## Proposal for 04 series of amendments to UN Regulation No. 129 (Enhanced Child Restraint Systems)

### Submitted by the Working Party on Passive Safety \*

The text reproduced below was adopted by the Working Party on Passive Safety (GRSP) at its seventy-third session (ECE/TRANS/WP.29/GRSP/73 paras. 22–35). It is based on ECE/TRANS/WP.29/GRSP/2023/13 as amended by annex VIII to the report, ECE/TRANS/WP.29/GRSP/2023/11 as amended by annex VIII to the report and ECE/TRANS/WP.29/GRSP/2023/14 as amended by para. 35 to the report. It is submitted to the World Forum for Harmonization of Vehicle Regulations (WP.29) and to the Administrative Committee (AC.1) for consideration at their November 2023 sessions.

"4.14. Additional markings

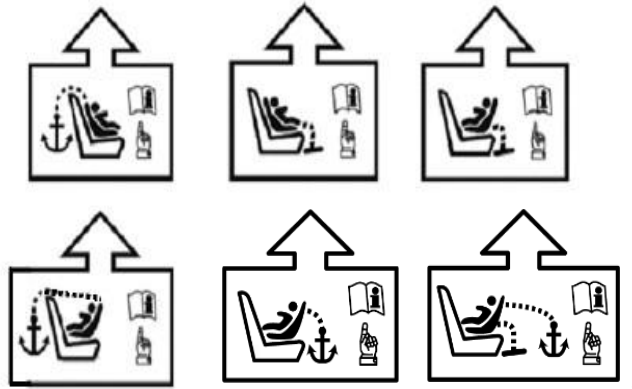
- (c) The position and if necessary, the routing of top tethers, lower tethers, or other means of limiting Enhanced Child Restraint System rotation requiring action by the user, shall be indicated using one or more of the following symbols as appropriate:

Figure 3 (f)

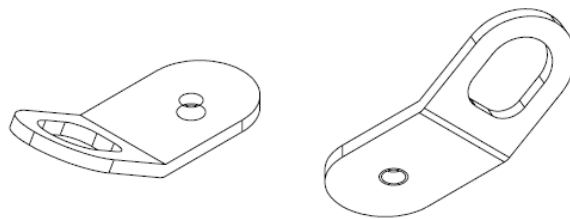
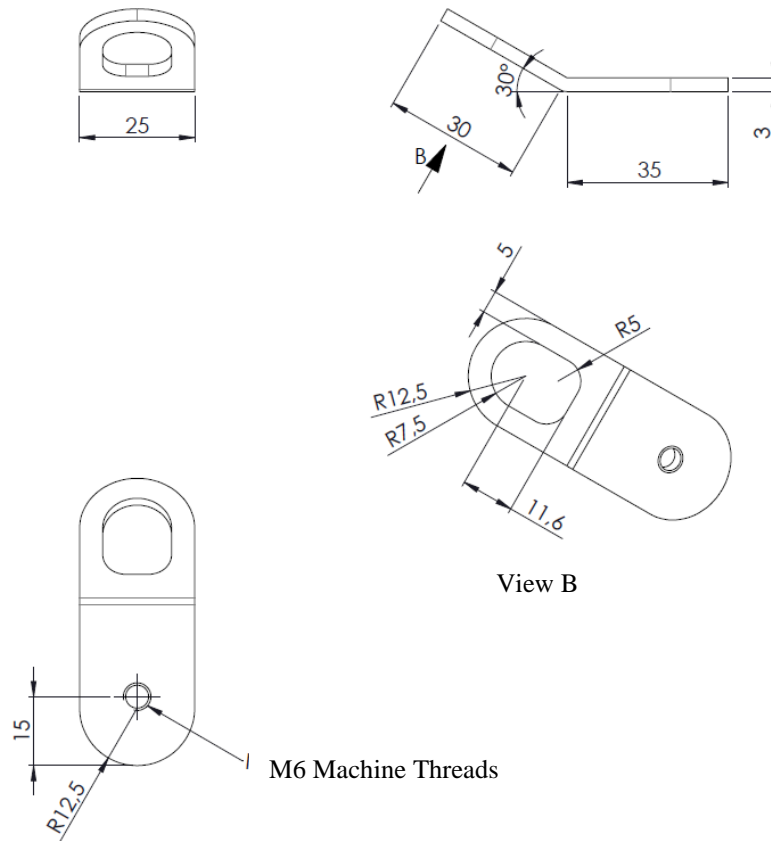
- 6.3.7.2. Dimensions bracket:
- (a) The generic lower tether bracket shall have dimensions according to Figure 3 (f);
  - (b) The outer edges of the lower tether bracket shall be at least blunted.

Figure 3 (g)

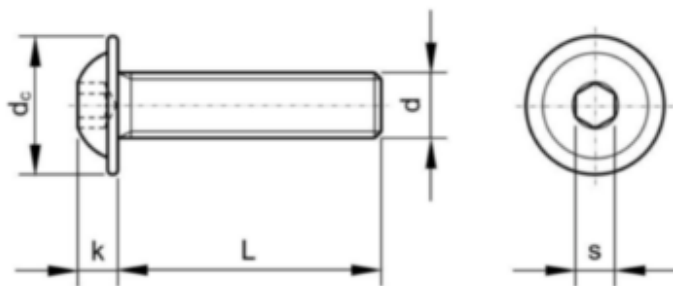
- (a) M6x8 flange buttonhead hexagon socket-cap screw see figure 3 (g);
- (b) M6 washer; see figure 3 (h);
- (c) M6 -8 shoulder washer; see figure 3 (i).

Specs	M6x8
L	8 mm
d <sub>c</sub>	13.6 mm
k	3.3 mm
d	M6
S	4 mm

Figure 3 (j)  
**Test 1**

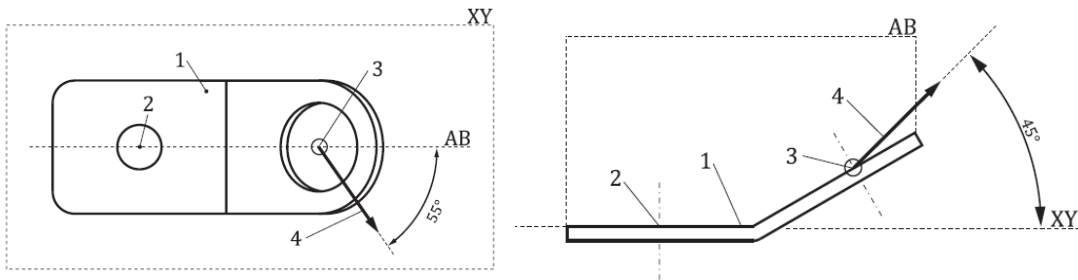
(a) the force shall be applied in a direction of  $55^\circ \pm 5^\circ$  against plane AB, measured in a plane parallel to the rigid surface XY, and a direction of  $45^\circ \pm 5^\circ$  against the rigid surface XY, measured in plane AB; rotation around the anchorage point to vehicle (2) shall be prevented. see figure 3 (j);

Figure 3 (k)  
**Test 2**

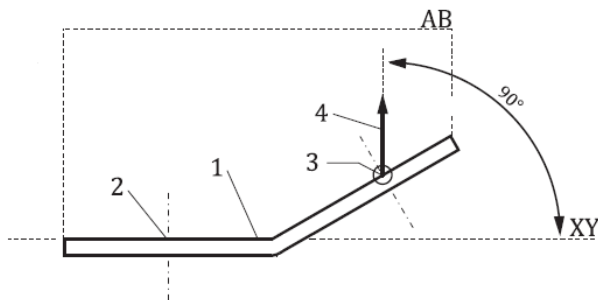
(b) the force shall be applied in a direction perpendicular ( $90 \pm 5^\circ$ ) to the rigid surface XY.

"Figure 5

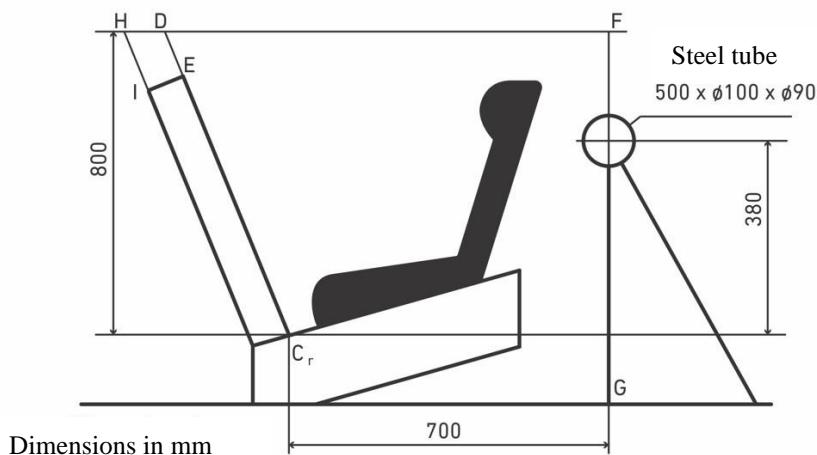
Figure 5, amend to read:

"Figure 5  
**Top View – Bench with Lower Tether Anchorages**  
**(LTA 1, LTA 2, LTA 3 and LTA 4)**

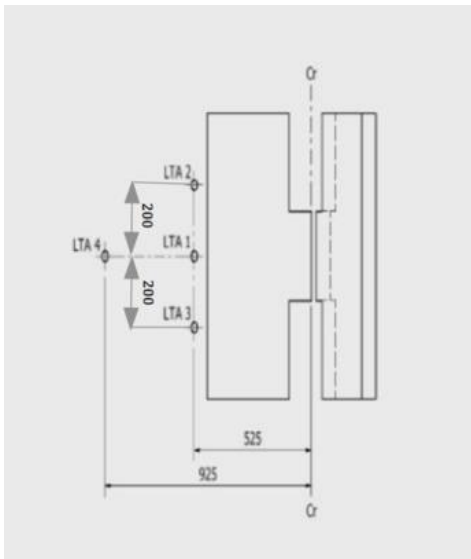
5. For the testing of Enhanced Child Restraint Systems with lower tether(s), the floor shall be placed in its lowest position. LTA 4 is to be used in case the top tether anchorage from the seat in front is used. Otherwise LTA 2 and LTA 3; see figure 5. Generic lower tether brackets to be used for the dynamic test in case they are provided by the CRS manufacturer.

Annex 6, Appendix 2, figure 5, amend to read:
